PENDLETON AVENUE
 FALL CREEK R.W.D. PLAN & PROFILE SHEET
 HORIZ. 1"=50'
 VERT. 1"=10'
 BEAM, LONGST & NEFF, INC.
 CONSULTING ENGINEERS
 INDIANAPOLIS, INDIANA
 54

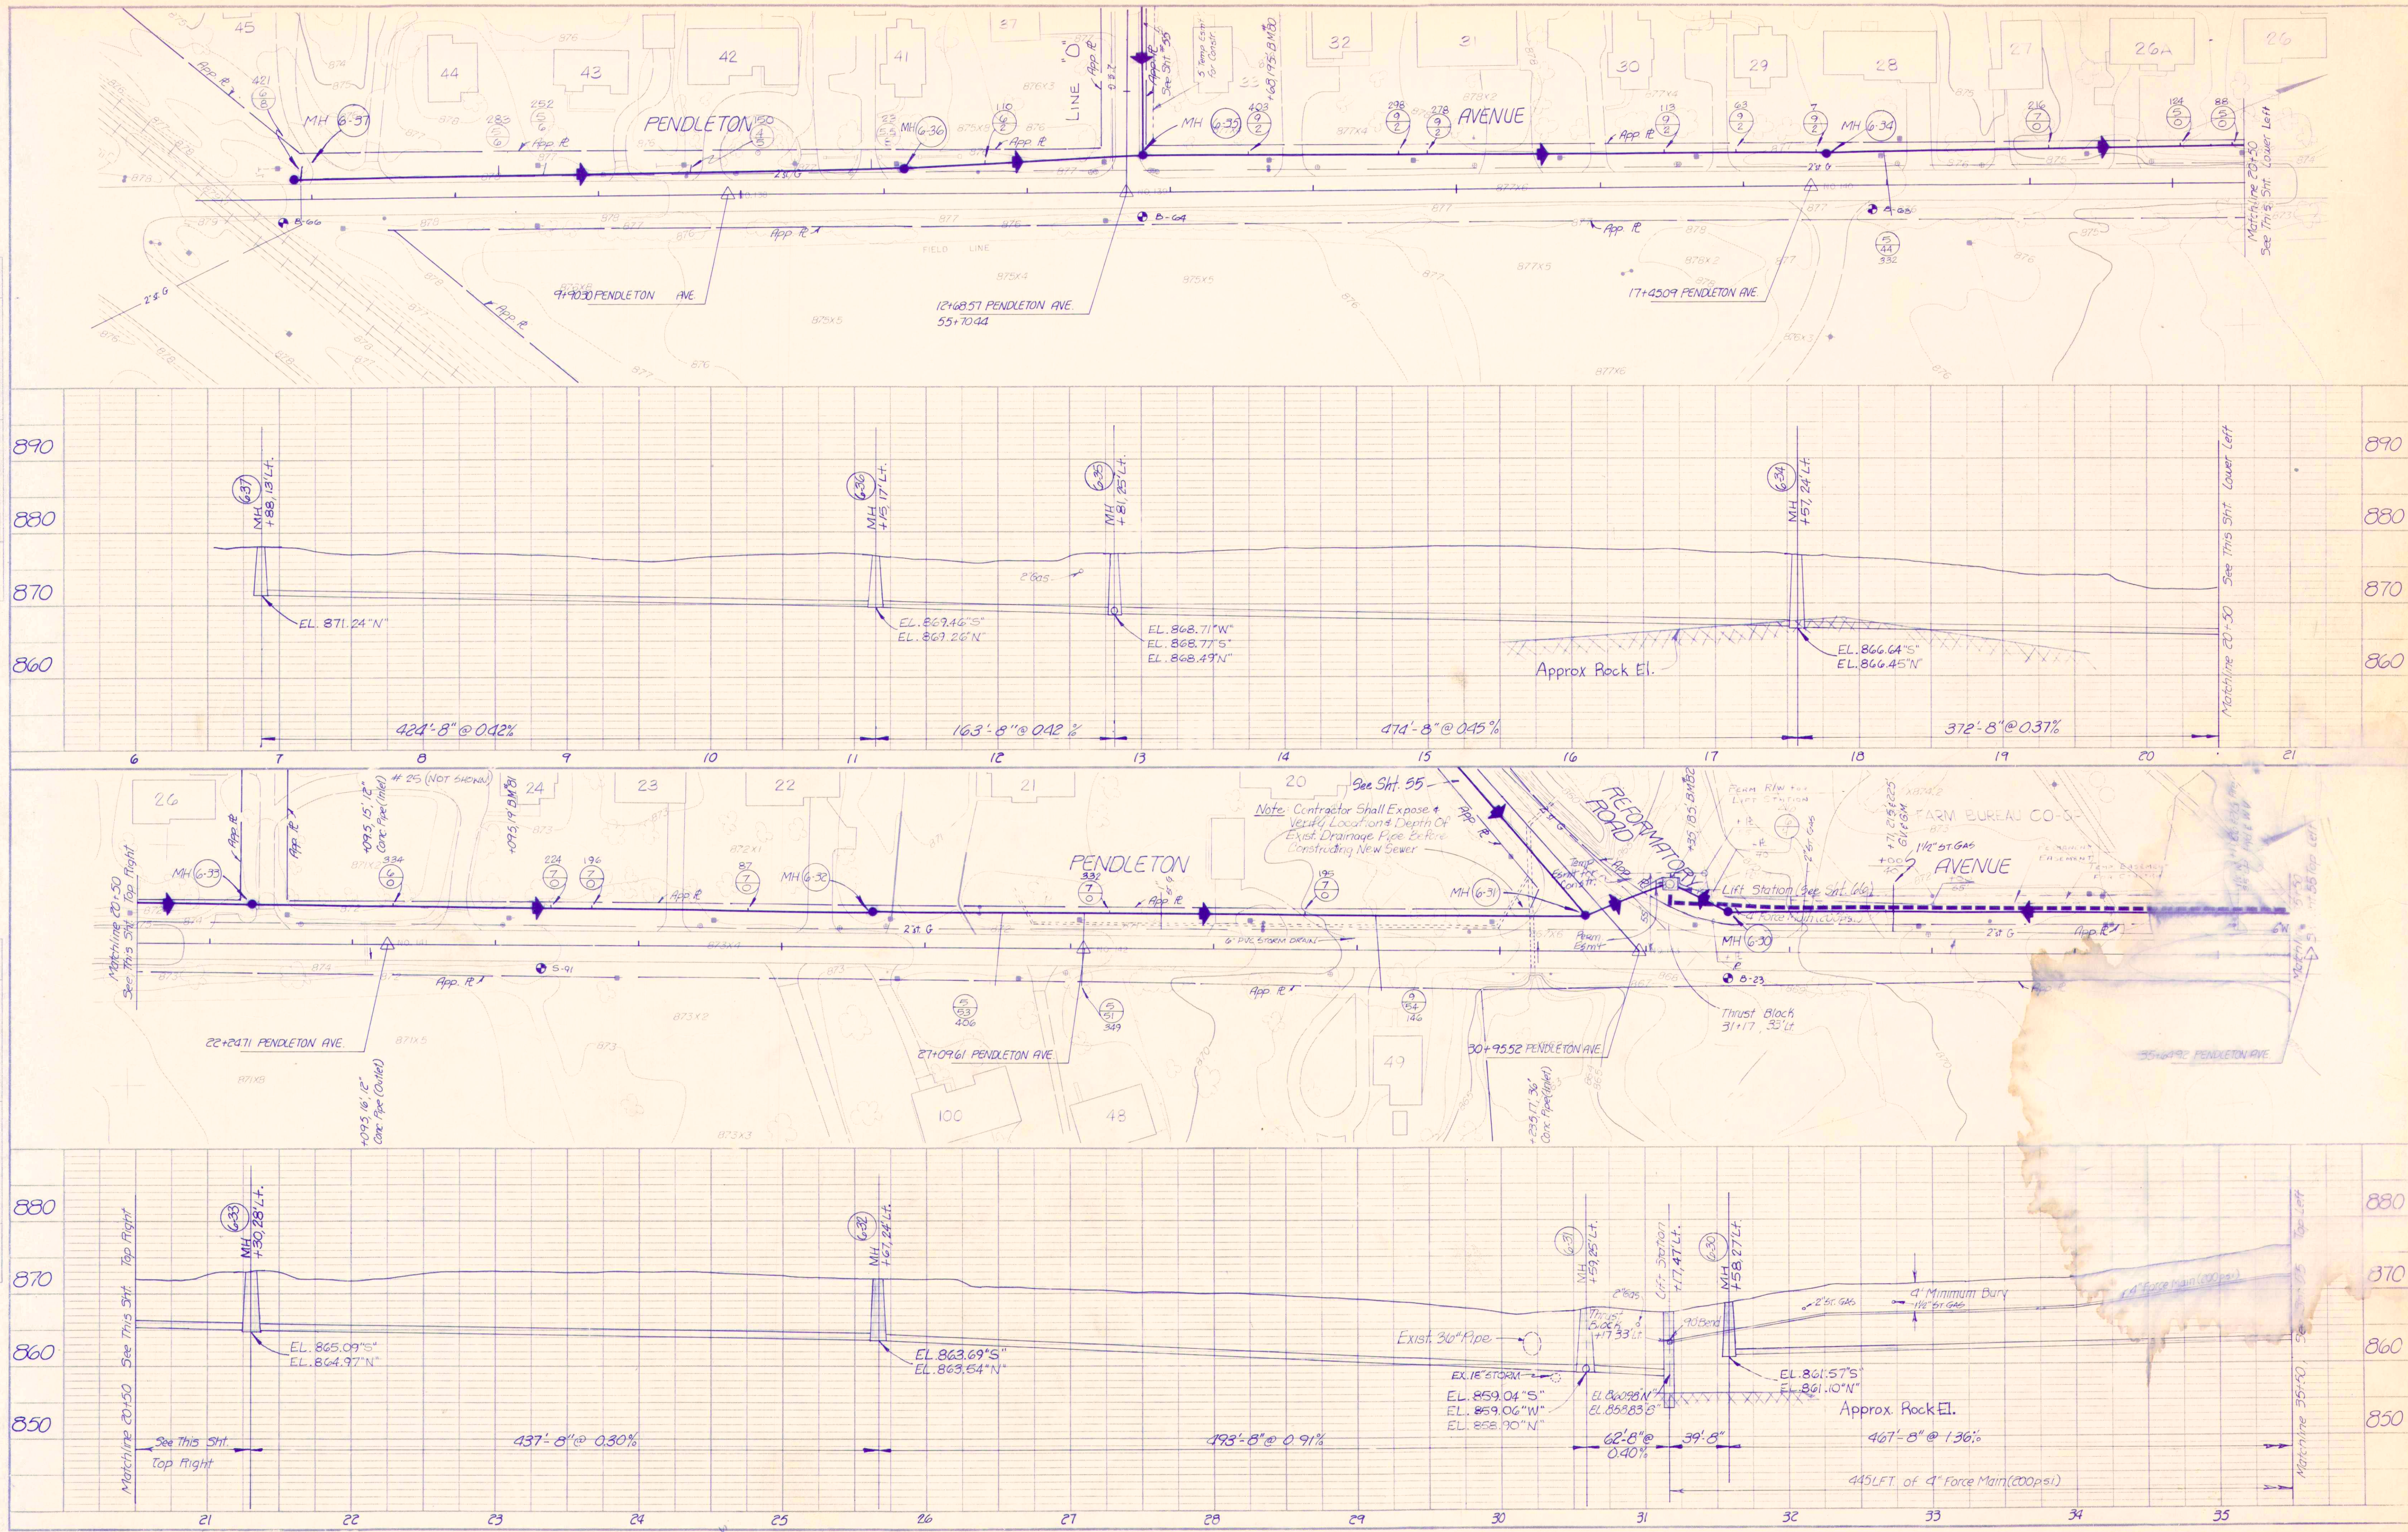
NEED REVISION
 TO IN/OUT THIS
 2. LIFT STATION
 3. NEED LIFT STATION
 4. NEED LIFT STATION
 5. NEED LIFT STATION
 6. NEED LIFT STATION
 7. NEED LIFT STATION
 8. NEED LIFT STATION
 9. NEED LIFT STATION
 10. NEED LIFT STATION
 11. NEED LIFT STATION
 12. NEED LIFT STATION
 13. NEED LIFT STATION
 14. NEED LIFT STATION
 15. NEED LIFT STATION
 16. NEED LIFT STATION
 17. NEED LIFT STATION
 18. NEED LIFT STATION
 19. NEED LIFT STATION
 20. NEED LIFT STATION
 21. NEED LIFT STATION
 22. NEED LIFT STATION
 23. NEED LIFT STATION
 24. NEED LIFT STATION
 25. NEED LIFT STATION
 26. NEED LIFT STATION
 27. NEED LIFT STATION
 28. NEED LIFT STATION
 29. NEED LIFT STATION
 30. NEED LIFT STATION
 31. NEED LIFT STATION
 32. NEED LIFT STATION
 33. NEED LIFT STATION
 34. NEED LIFT STATION
 35. NEED LIFT STATION

REVISION 3-19-94
 CHANGE P.W. AROUND
RECORD DRAWING
 Changed Grads From MH 6-31
 To MH 6-28
